Enclosure 4 to E-55865

SAR Changed Pages

Figure 7-54
Isometric View of Cask Handling Building Structural Steel Framing

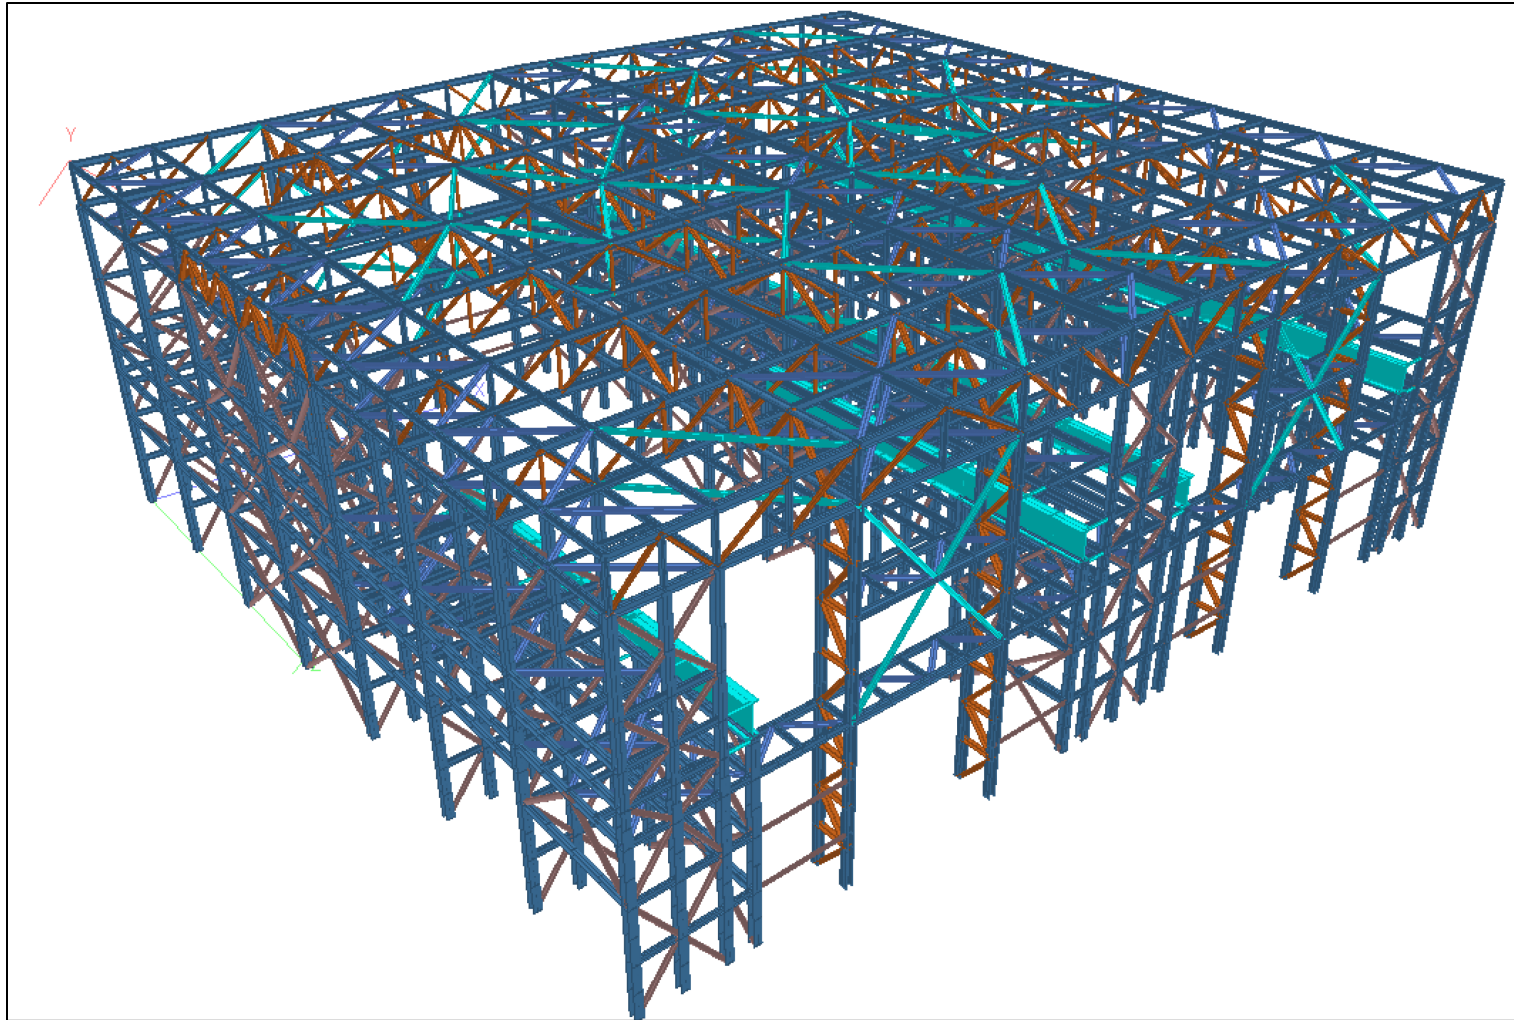
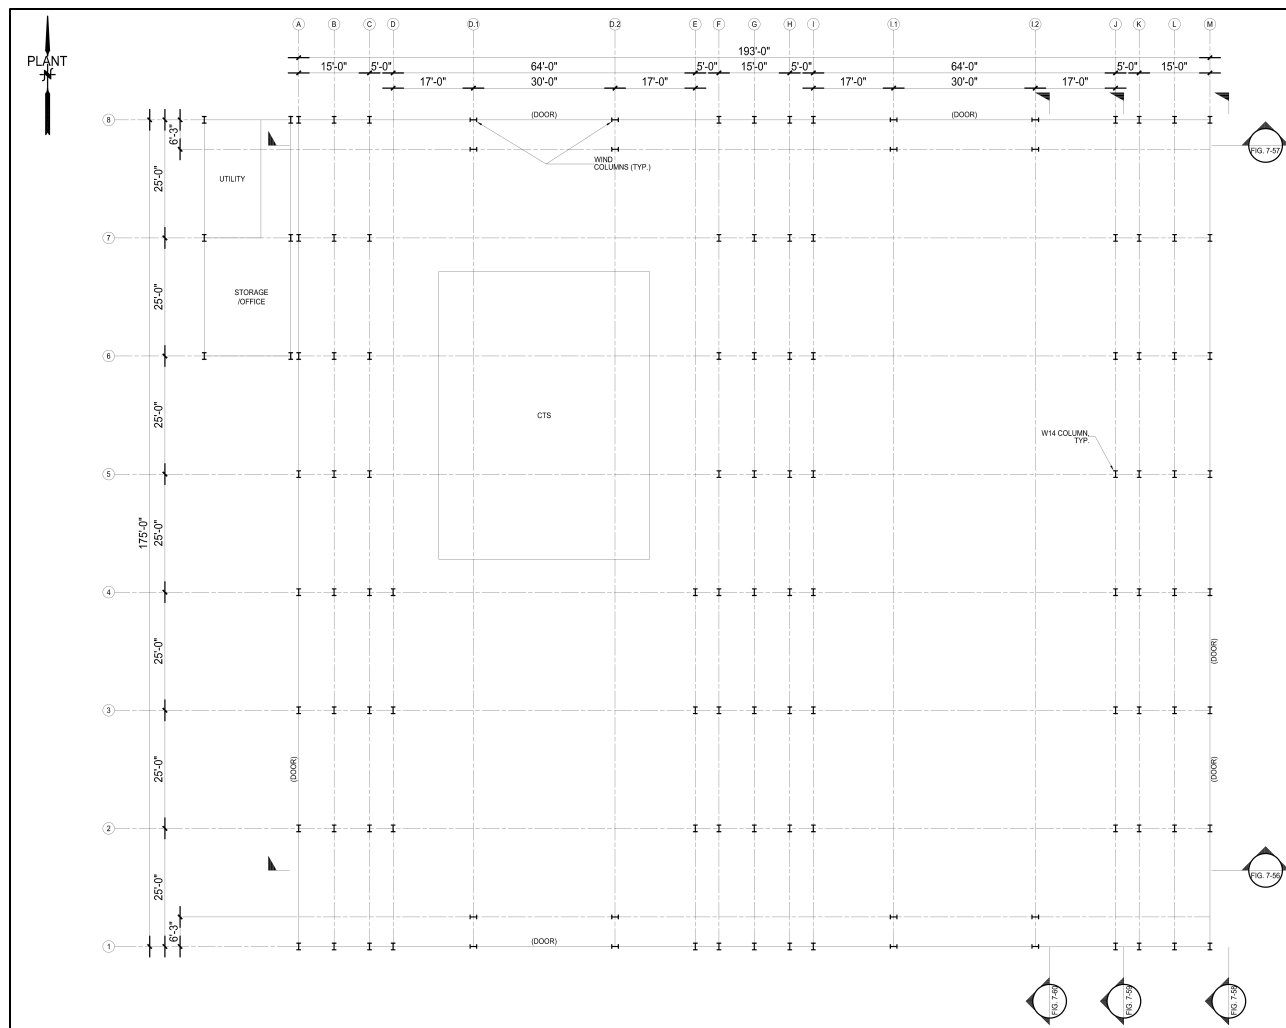
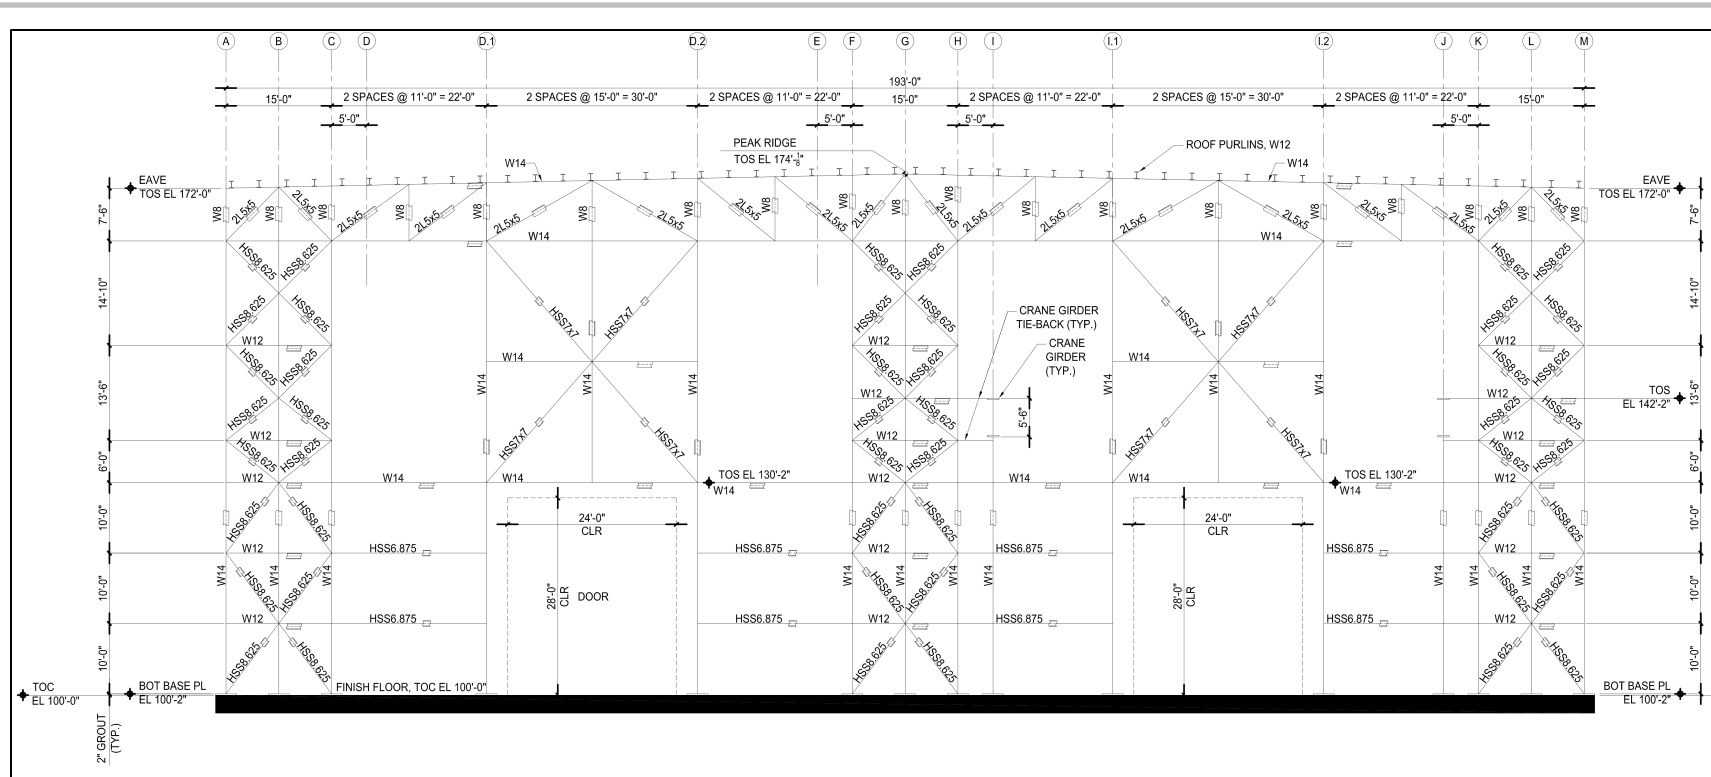
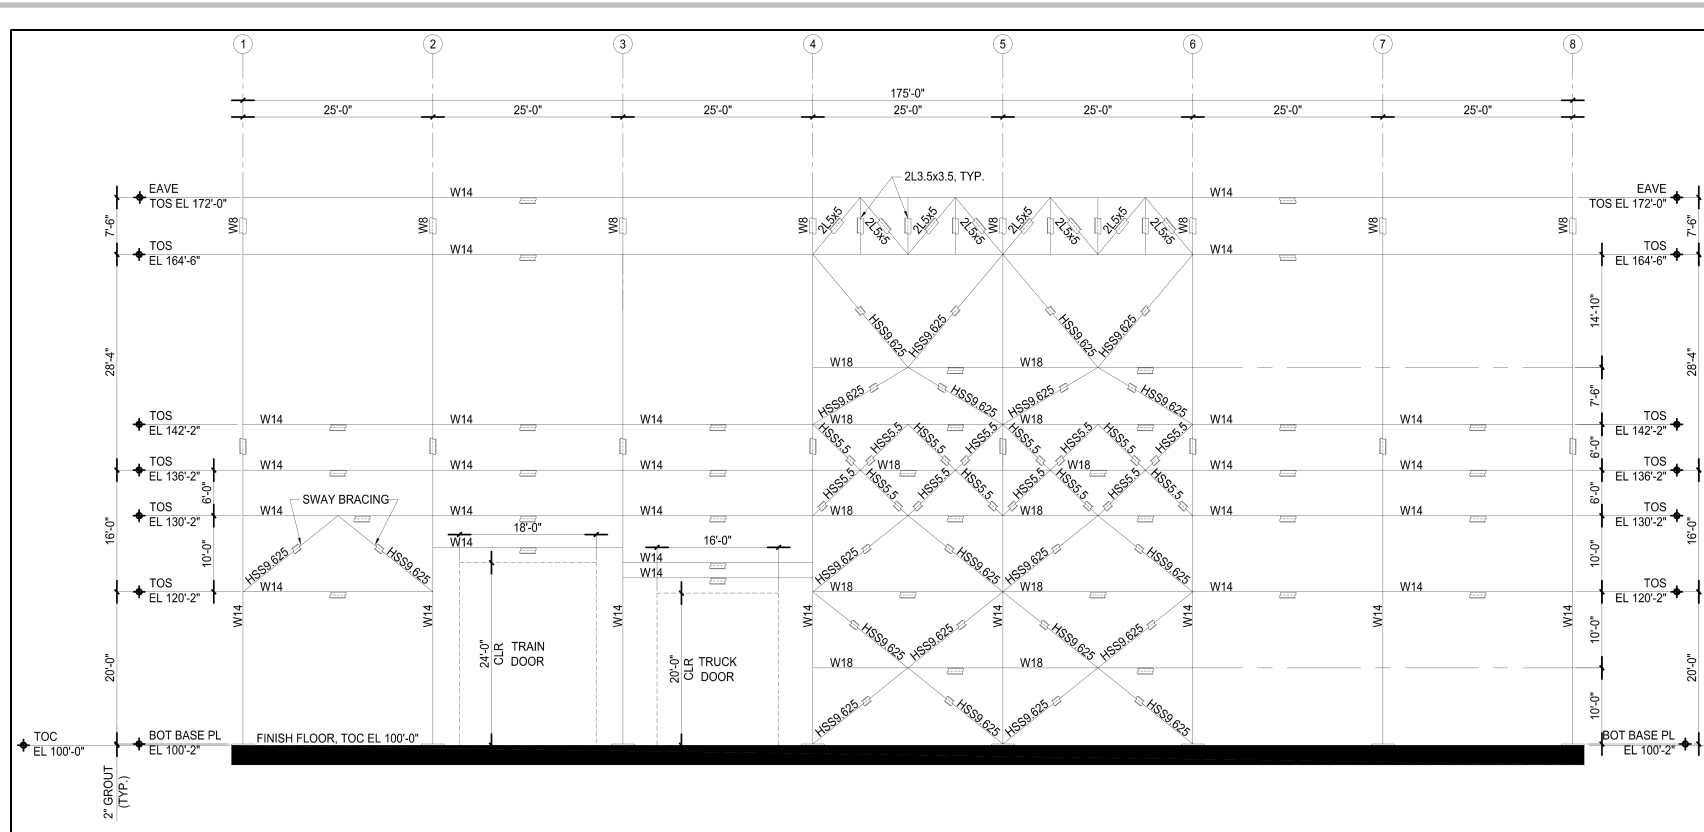
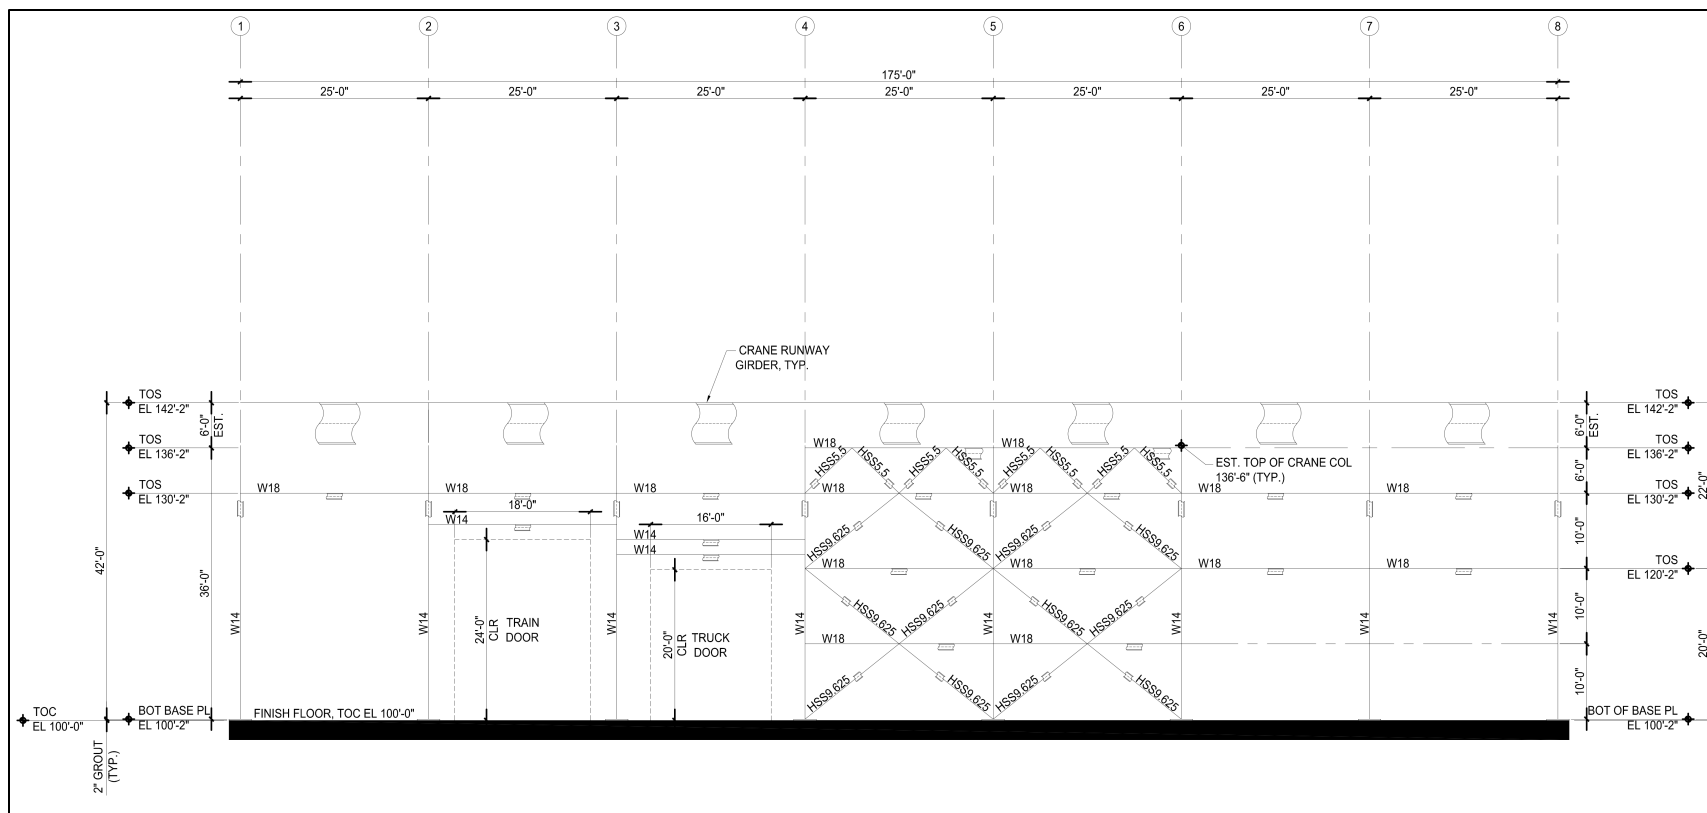
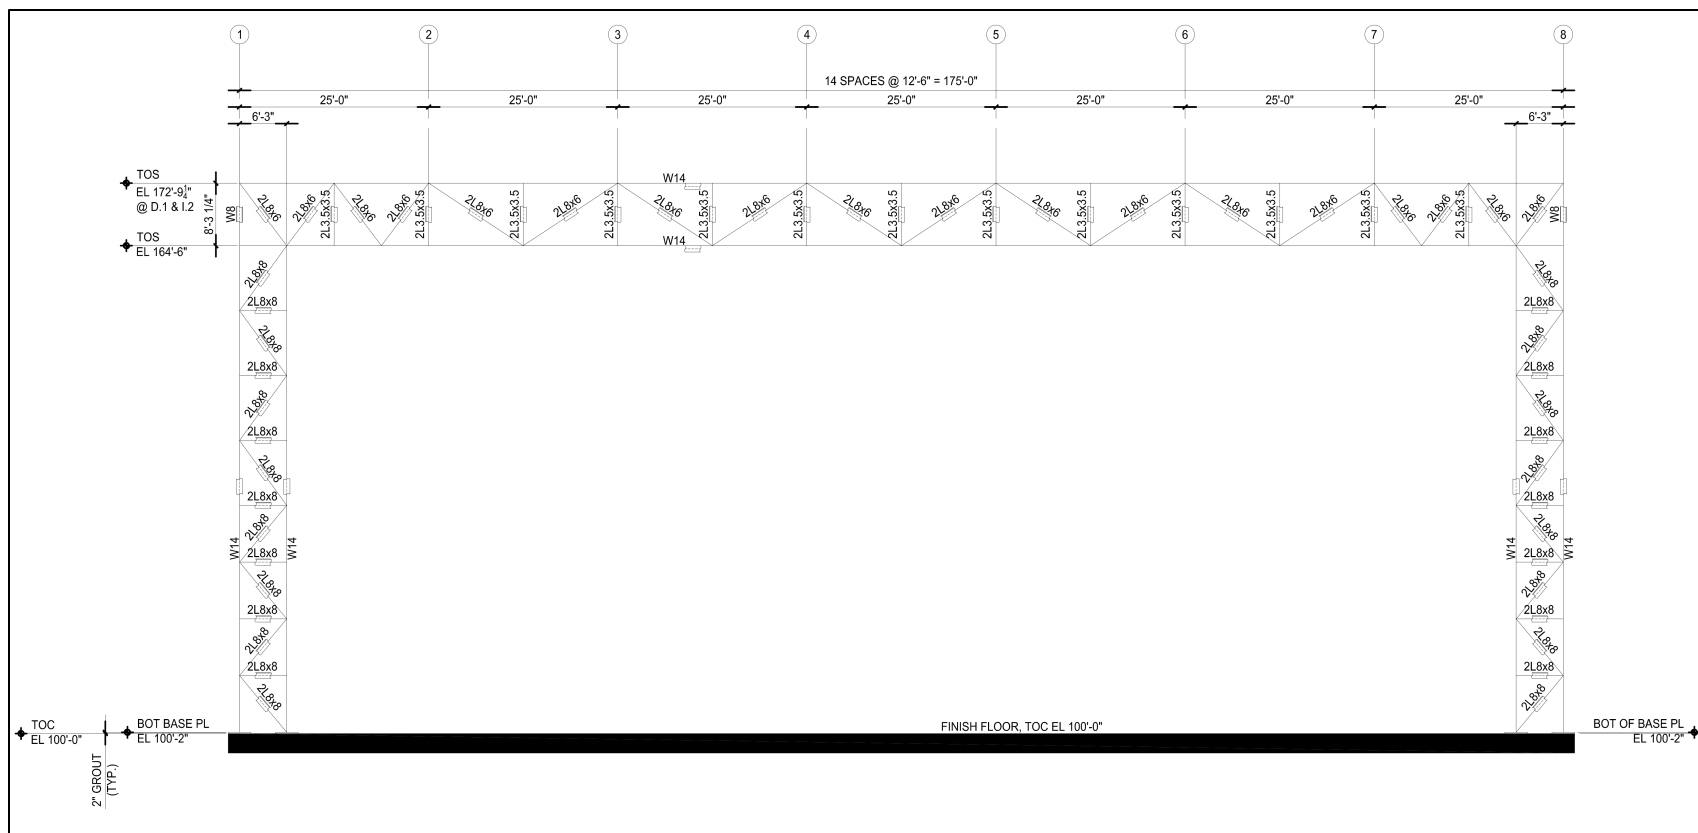
As shown in Figures 7-54 through 7-61, the CHB steel building is a braced frame structure with column centerline grid plan dimensions of 175'-0" (north-south) by 193'-0" (east-west) and an eave height 72'-0" above the top of the concrete foundation (Elevation 100'-0" in the figures). The roof is gabled with 1/4-inch per foot slope on each side and peak ridge elevation of 174'-0 1/8". The north-south plan dimension of the building comprises seven equal bays of 25'-0" spacing, with vertically braced interior bays similar to those shown in Figure 7-56 on column lines A, C, F, H, K, and M. The east-west plan dimension comprises two crane bays with 64'-0" spacing between independent crane support columns that are laterally supported by three separate vertically braced frames at column lines A-C, F-H, and K-M (see Figures 7-55 and 7-56). All seven east-west column lines support a primary lateral roof truss system that is tied together with a secondary north-south bridging roof truss system and horizontal roof bracing at the top and bottom truss chord levels. The primary roof trusses vary in depth from 7'-6" at the eave to 9'-6 1/8" at the ridge. The vertical bracing and primary roof truss arrangement is shown in Figure 7-56, with the secondary bridging roof trusses and horizontal roof truss chord bracing shown in Figures 7-60 and 7-61, respectively.

Figure 7-55 through Figure 7-60 illustrate typical member size groups utilized for CHB primary framing. Member size classes utilized for each primary framing member category are also summarized in Table 7-41. Further discussion of the CHB structural steel analysis and design is given in Sections 7.5.3.3 and 7.5.3.4.

To evaluate the performance of the CHB steel framing shown in Figures 7-54 through 7-61, the building is modeled in a detailed three-dimensional structural analysis model and subjected to all of the applicable design load cases and load combinations defined above in Sections 7.5.3.2.1 and 7.5.3.2.2. The assumption of linear elastic response for static, seismic, and tornado wind loads permits separate analysis of each loading condition and superposition of applicable load case member forces and moments to determine total load combination demands for evaluation vs. code defined member capacities.
